## HISTORIC AND DESIGN REVIEW COMMISSION

December 20, 2017

**HDRC CASE NO:** 2017-646  
**ADDRESS:** 524 E EVERGREEN  
**LEGAL DESCRIPTION:** NCB 398 BLK 18 LOT 7 & E 10 FT OF 6  
**ZONING:** RM-4 H  
**CITY COUNCIL DIST.:** 1  
**DISTRICT:** Tobin Hill Historic District  
**APPLICANT:** Frank Velez/Ability Construction & Iron Works  
**OWNER:** Pedro Rodriguez  
**TYPE OF WORK:** wrought iron front yard fence  
**APPLICATION RECEIVED:** December 06, 2017  
**60-DAY REVIEW:** February 05, 2018  
**REQUEST:**

The applicant is requesting a Certificate of Appropriateness for approval to install front yard wrought iron fence at 5 feet in height.

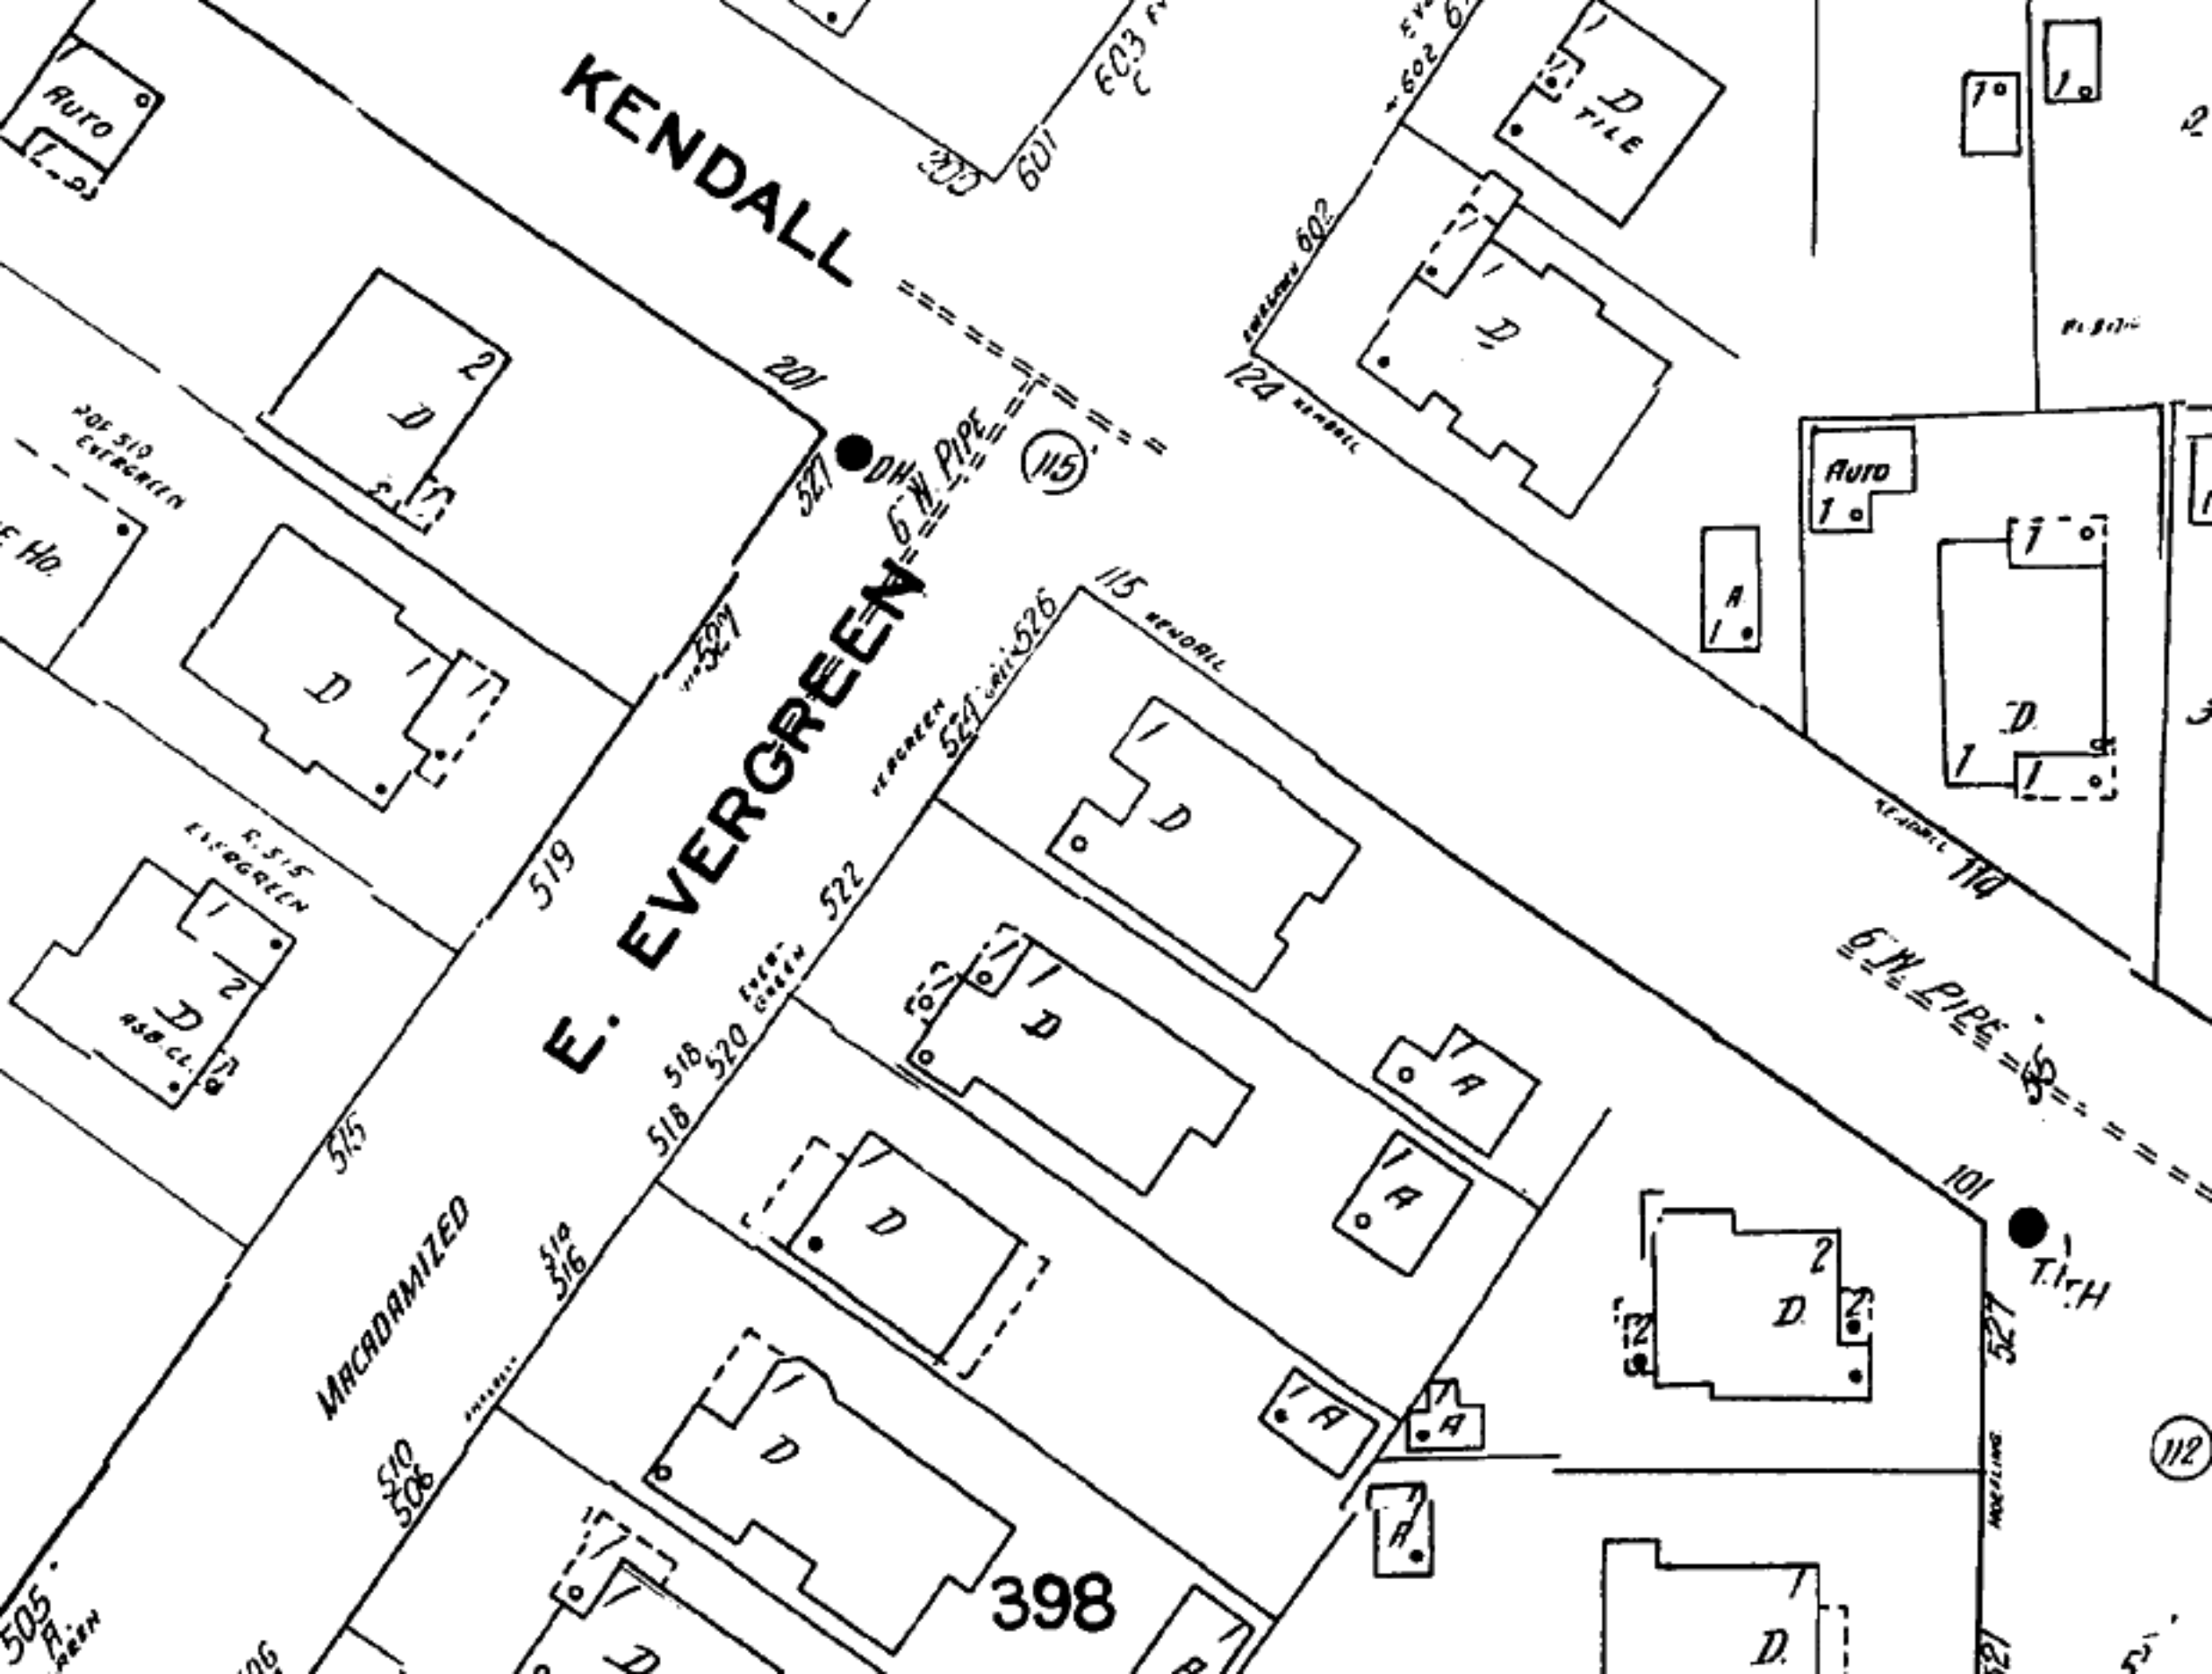
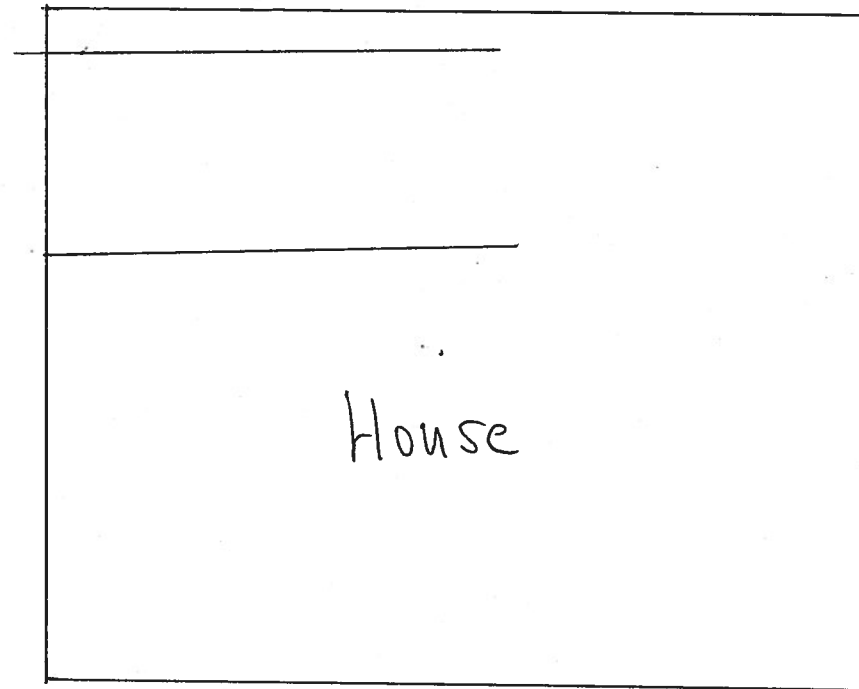
iron fencing spanning the front yard on E Evergreen to the rear corner on cross-street Kendall, including an arched driveway gate towards the rear of the property. Any replacement must be consistent with the Historic Design Guidelines and development standards related to front yard fencing. Per the Guidelines, front yard fences should not exceed four feet in height. Staff finds the proposed height should be reduced to be consistent with the Guidelines.

- c. **DESIGN/MATERIAL**—The applicant proposed to use wrought iron fencing with an arched gate. Wrought iron fences are found throughout the Tobin Hill Historic District. Staff finds that the proposed fence is appropriate provided that no portion of the fence exceeds four feet in height including the rear gate.

Staff recommends approval of the installation of a front yard wrought iron fence on this corner lot with the stipulation that no portion of the fence exceeds four feet in height.
